**M E M O R A N D U M**

**SUBJECT:** Response to Comments on Buchanan Street Bicycle/Pedestrian Path Project Initial Study/Draft Mitigated Negative Declaration

FIGURE 2

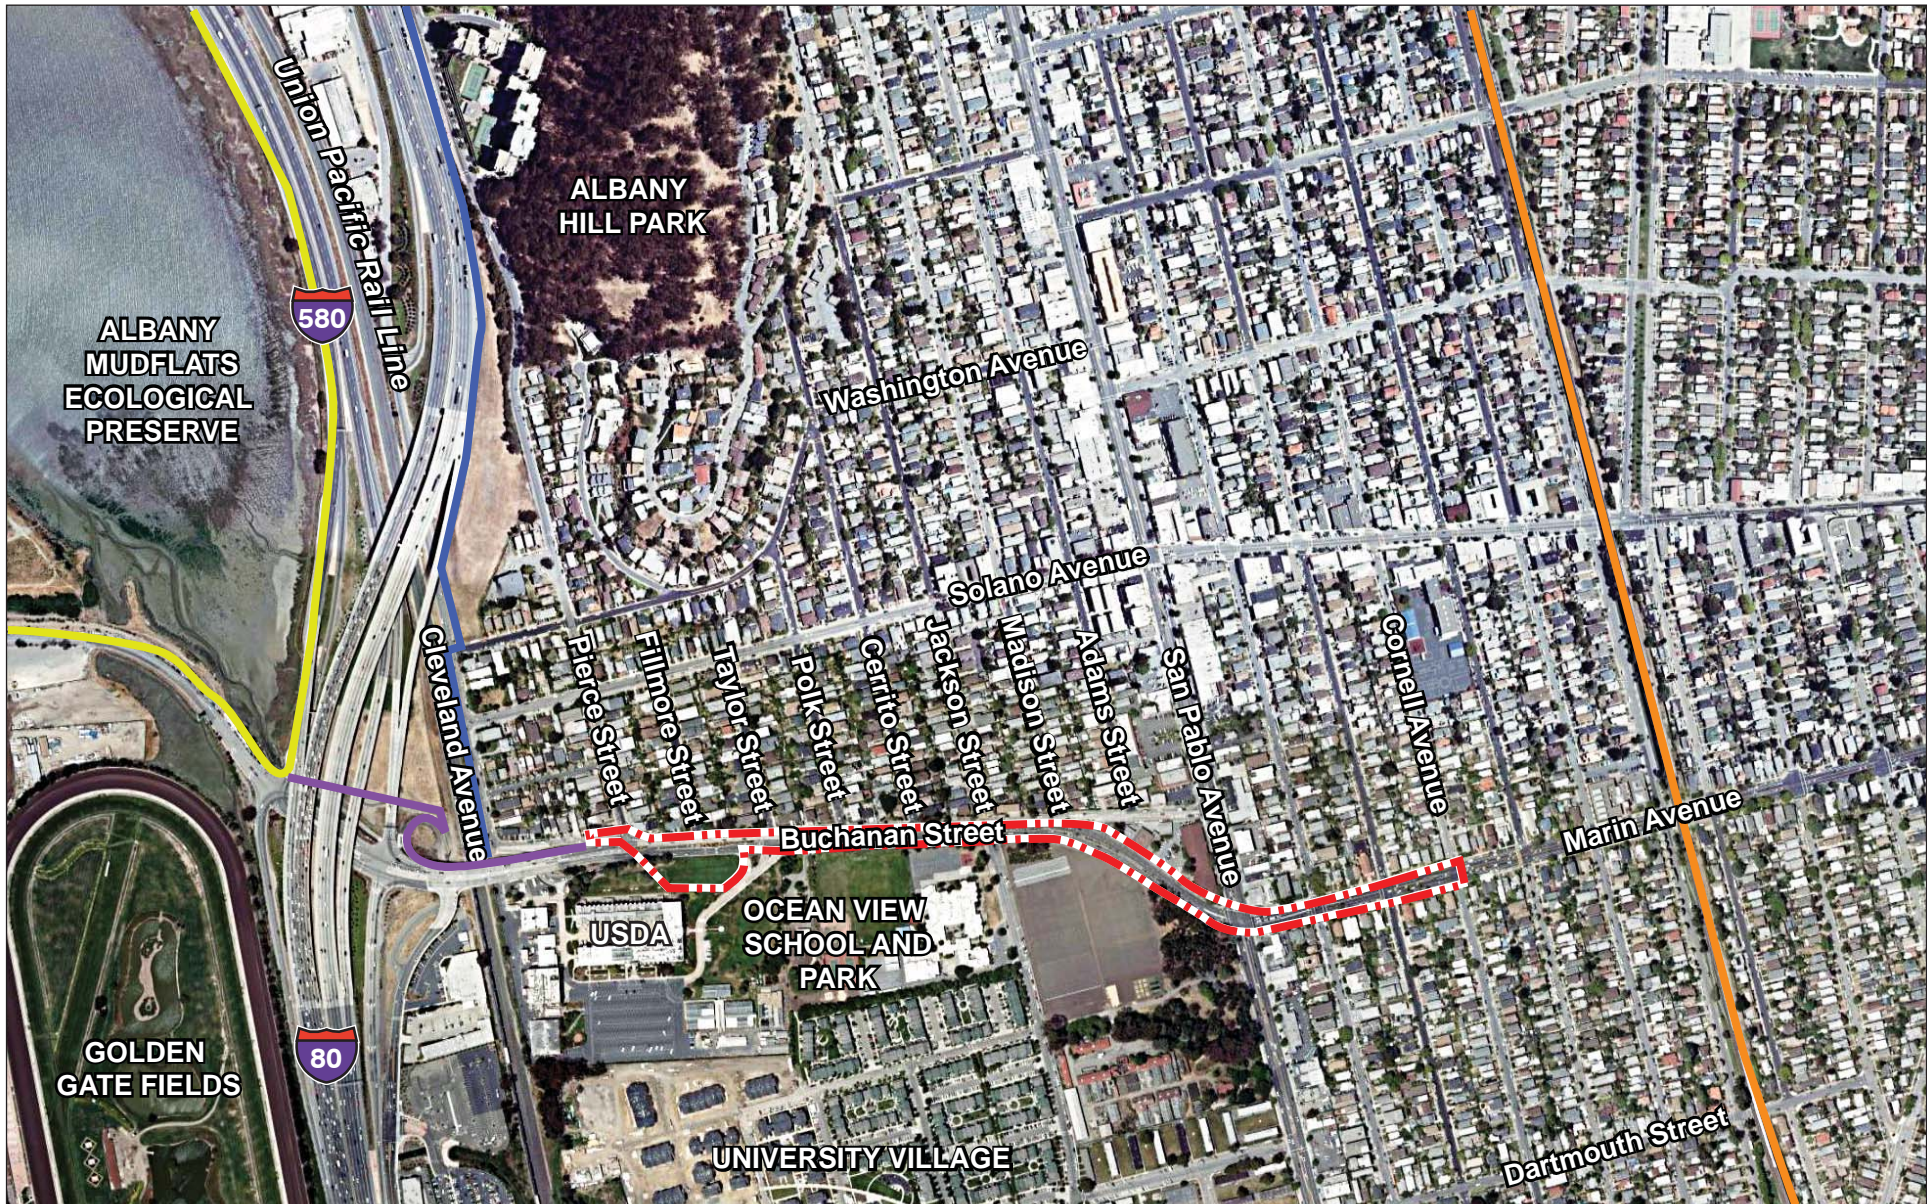
Figure 2 (Aerial Photograph and Surrounding Land Uses) on page 5 of the Draft IS/MND is revised to show the correct alignment of the Buchanan Street Connector Trail (labeled in purple). An approximately 500-foot segment of the alignment as it crosses beneath the freeway was incorrectly labeled to show the path's previous alignment. The corrected figure is provided on the following page.
